Date of Issue: May 2024

Affected Publication: API Specification 5CT, *Casing and Tubing*, 11th Edition, December 2023

Errata 1

Figure D.17—Examples of Marking Requirements and Sequence for Manufacturers and Threaders Using Section 10 and Table C.43 or Table E.43 (continued)

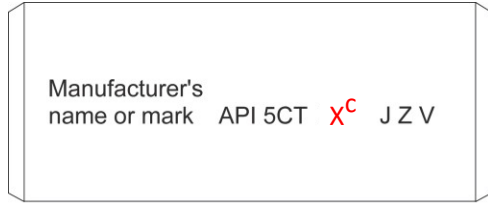
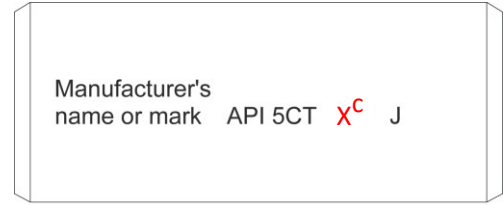
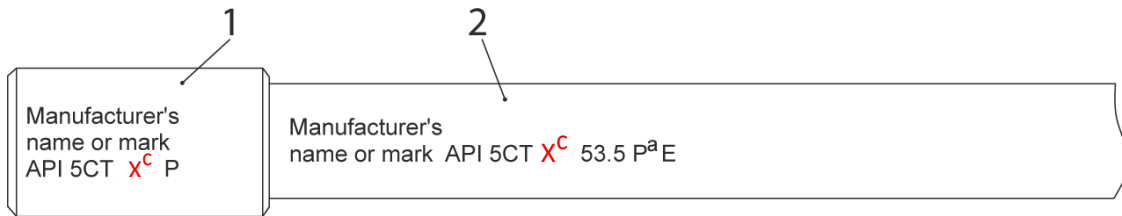
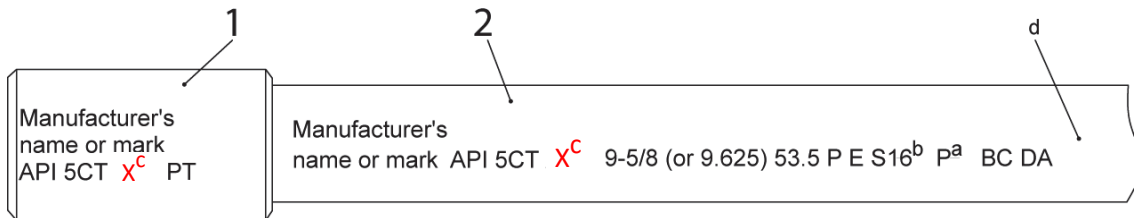
Figure D.17: Figures and Note c shall be changed as indicated by the red markup below:

- c Date of manufacture—This example is for product manufactured in accordance with the current edition of API 5CT during the period of overlap with application (see 10.1.9) of the previous edition. **Note that "X" is used for the date of manufacture so that it is a generic example that will not change with subsequent editions of this standard.**
